UNITED STATES PATENT AND TRADEMARK OFFICE

Office Action Summary	Application No. 10/510,351	Applicant(s) BODNAR, ERNEST R.	
	Examiner CHRISTINE T. CAJILIG	Art Unit 3633

Title : STEEL STUD WITH OPENINGS AND EDGE FORMATIONS
AND METHOD

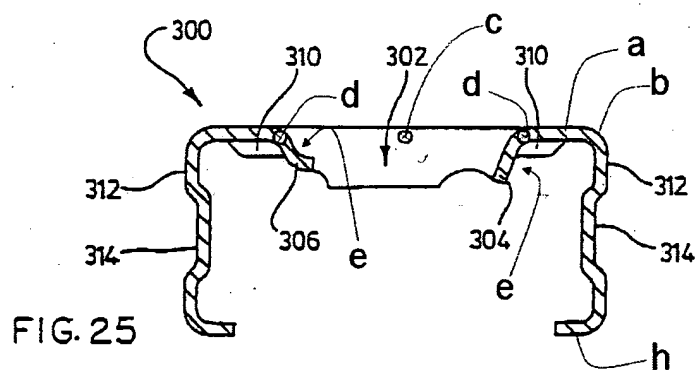
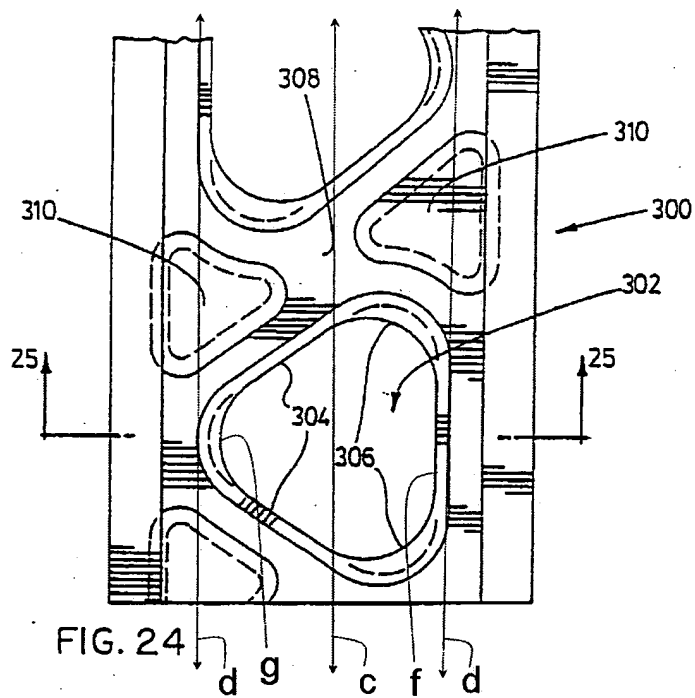
Regarding claim 1, Rafter '384 in Figure 1 discloses a metal member for use in supporting structures and having reduced heat transfer characteristics as compared with solid web studs, and characterized by a web (1) defining side edges and an axis (a); a flange (5) on at least one side edge; openings (2) through said web at spaced intervals therealong, of predetermined size and profile, at least a side portion (3, 4) of said web being removed from said opening and remaining attached integrally to said web, and being bent away from said web along axes (b) parallel to said web axis (a), but does not disclose that the member is steel. However, it would have been obvious to one having ordinary skill in the art at the time of invention to use steel, since it has been held to be within the general skill of a worker in the art to select a known material on the basis of its suitability for the intended use as a matter of obvious design choice. *In re Leshin*, 227 F.2d 197, 125 USPQ 416 (CCPA 1960)

Regarding claim 3, Rafter '384 discloses the structure discussed above and further discloses that said side portion (3, 4) defines a channel shape (created by 3 and 4) extending along an axis (between axes a and b) parallel to said web axis.

Bodnar '625

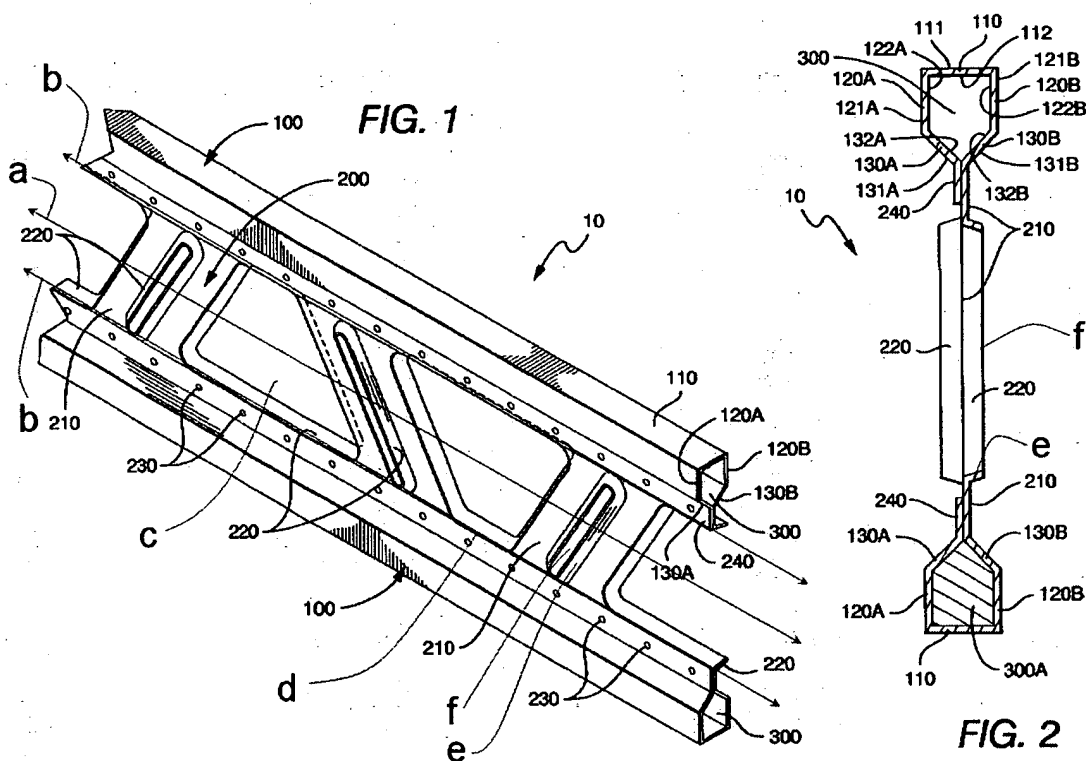
Regarding claim 1, Bodnar '625 in Figures 24-25 discloses a steel member for use in supporting structures and having reduced heat transfer characteristics as compared with solid web studs, and characterized by a web (a) defining side edges and an axis (c); a flange (312) on at least one side edge; openings (302) through said web at spaced intervals therealong, of predetermined size and profile, at least a side portion (304, 306) of said web being removed from said opening and remaining attached integrally to said web, and being bent away from said web along axes (d) parallel to said web axis (c).

Regarding claim 3, Bodnar '625 discloses the structure discussed above and further discloses that said side portion (304, 306) defines a channel shape (e) extending along an axis parallel to said web axis.

Regarding claim 4, Bodnar '625 discloses the structure discussed above and further discloses that said openings (302) are of a shape defining a linear side edge (f), and an arcuate side edge (g), said side portion (304, 306) of said web being integral with said linear side edge (f).

Regarding claim 5, Bodnar '625 discloses the structure discussed above and further discloses that there are two said flanges (312) one on each side of said web, being formed at normal to said web, and lips (h) formed along said flanges and normal to said flanges.

Regarding claim 6, Bodnar '625 discloses the structure discussed above and further discloses that openings (302) are arranged in an alternating orientation and struts (308) are defined between said openings, said struts extending diagonally across said member.

Regarding claim 26, Bodnar '625 in Figures 24-25 discloses a steel member having a web (a), side edges, and a flange (312) along at least one said side edge and openings (302) through said web wherein said openings (302) are formed in said web at spaced intervals therealong, with one of said openings leaving a side portion of metal attached to said web forming an edge flange (304, 306) along said at least one side edge of said web and forming said side portion out of the plane of said web wherein said side portion is bent along bend lines (d) parallel to the web axis (c). Therefore, the method steps set forth in claim 26 of forming the steel member with the above said structure and bending side portions would have been an obvious if not inherent method of making the steel member having the same structure.

Meyer '217

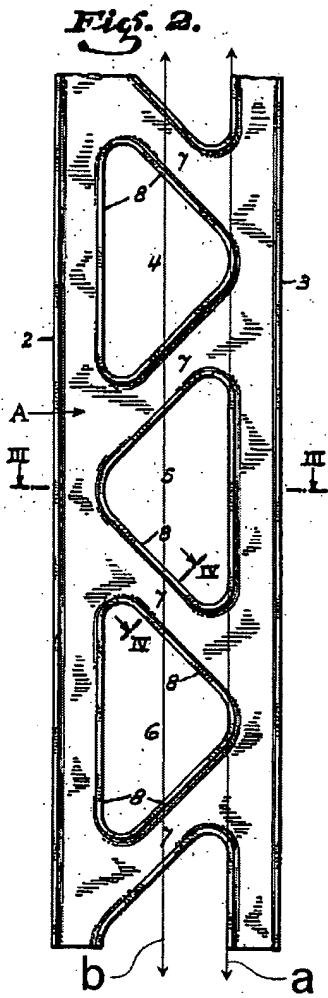
Regarding claim 1, Meyer '217 in Figures 1 and 2 discloses a steel member for use in supporting structures and having reduced heat transfer characteristics as compared with solid web studs, and characterized by a web (210) defining side edges and an axis (a); a flange (120a, 110) on at least one side edge; openings (c) through said web at spaced intervals therealong, of predetermined size and profile, at least a side portion (d, 220) of said web being removed from said opening and remaining attached integrally to said web, and being bent away from said web along axes (b) parallel to said web axis (a).

Regarding claim 2, Meyer '217 discloses the structure discussed above and further discloses depressions (e) formed in said web at spaced intervals, and an opening (f) formed in said depressions to reduce heat transfer.

Folsom '781

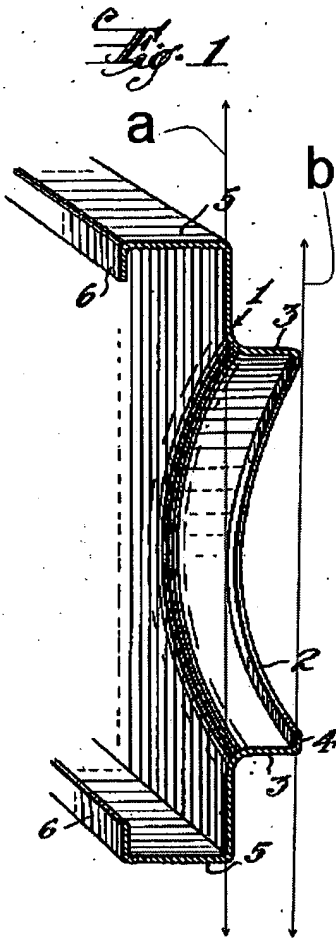
compared with solid web studs, and characterized by a web (A) defining side edges and an axis (b); a flange (3) on at least one side edge; openings (4-6) through said web at spaced intervals therealong, of predetermined size and profile, at least a side portion (8) of said web being removed from said opening and remaining attached integrally to said web, and being bent away from said web along axes (a) parallel to said web axis (b), but does not disclose that the member is steel. However, it would have been obvious to one having ordinary skill in the art at the time of invention to use steel, since it has been held to be within the general skill of a worker in the art to select a known material on the basis of its suitability for the intended use as a matter of obvious design choice. *In re Leshin*, 227 F.2d 197, 125 USPQ 416 (CCPA 1960)

Regarding claim 6, Folsom '781 discloses the structure discussed above and further discloses that said openings (406) are arranged in an alternating orientation and struts (7) are defined between said openings, said struts extending diagonally across said member.

Regarding claim 26, Folsom '781 discloses a steel member having a web (A), side edges, and a flange (3) along at least one said side edge and openings (4-6) through said web wherein said openings (4-6) are formed in said web at spaced intervals therealong, with one of said openings leaving a side portion of metal attached to said web forming an edge flange (8) along said at least one side edge of said web and forming said side portion out of the plane of said web wherein said side portion is bent along bend lines (a) parallel to the web axis (b). Therefore, the method steps set forth in claim 26 of forming the steel member with the above said structure and bending
